# SERVICE BULLETIN

No. 595

Piper Aircraft Corporation

Subject: Elevator Outboard Hinge Bracket Rivets Replacement

TOP VIEW OF LEFT ELEVATOR SHOWN - RIGHT ELEVATOR OPPOSITE

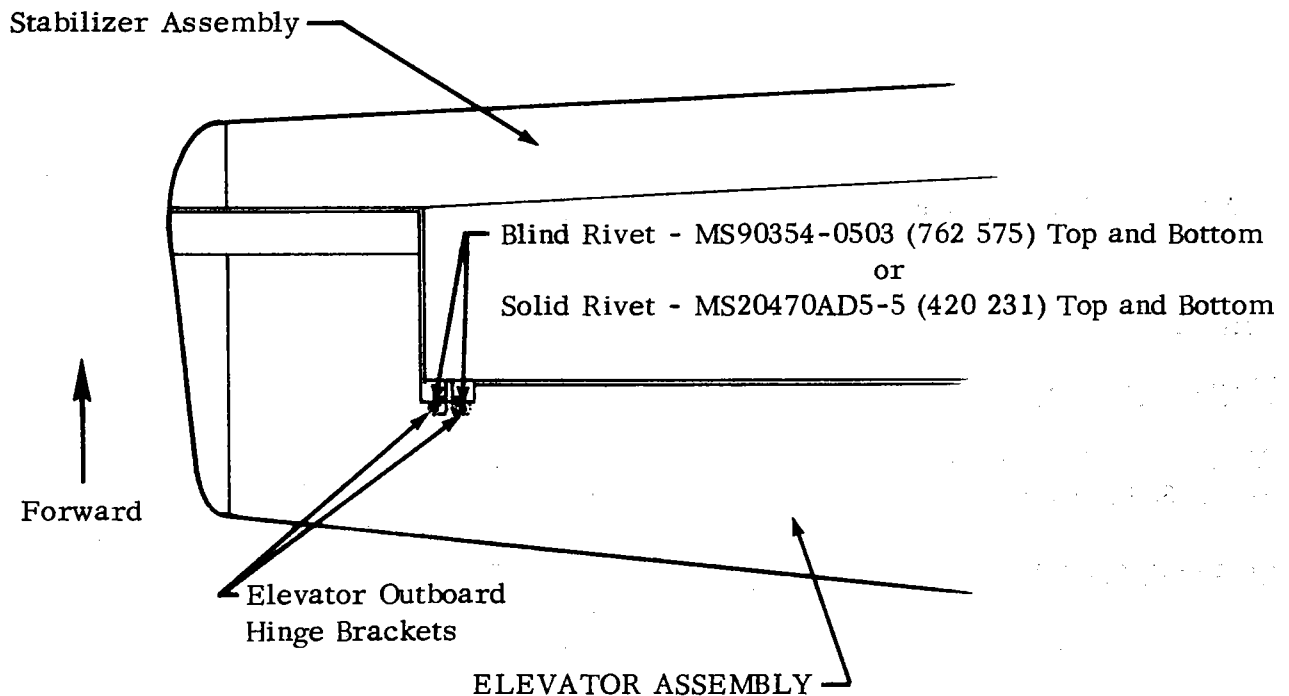
Purpose: It has been determined that in the above referenced aircraft there exists a possibility of the rivets for the upper and lower attach point on the elevator outboard hinge bracket shearing and remaining undetected.

1. Locate the two outboard elevator hinge brackets, on the left and right elevators, as shown on sketch above.
2. Replace existing MS20470AD4 solid rivets, attaching elevator hinge brackets to spar flange and skin, with MS90354-0503 blind rivets as follows. (If the MS90354-0503 blind rivets cannot be installed, due to lack of equipment etc., proceed to step 3 for alternate MS20470AD5-5 solid rivet installation. ) Accomplish on left and right elevator assemblies.

- a. Remove one of the four (4) existing hinge bracket rivets as shown above. Removing one rivet at a time will prevent misalignment of the outboard elevator hinge brackets.

- b. Enlarge the rivet hole to .166 dia. (#19 drill). Install MS90354-0503 rivet.
  - c. Repeat steps a. and b. above for each of the three (3) remaining rivets.

- d. Make proper logbook entry of Service Bulletin 595 compliance.
3. If MS90354-0503 blind rivets cannot be installed, it will be acceptable to install MS20470AD5-5 solid rivets as follows. Accomplish on left and right elevator assemblies.

- a. Refer to appropriate Navajo Service Manual and remove elevator assembly.
  - b. Remove one of the four (4) existing hinge bracket rivets as shown above. Removing one rivet at a time will prevent misalignment of the elevator hinge brackets.

- c. Enlarge the rivet hole to .166 dia. (#19 drill). Install MS20470AD5-5 rivet.
  - d. Repeat steps b. and c. above for each of the three (3) remaining rivets.

- e. Reinstall elevator assembly per appropriate Navajo Service Manual.
  - f. Make proper logbook entry of Service Bulletin 595 compliance.
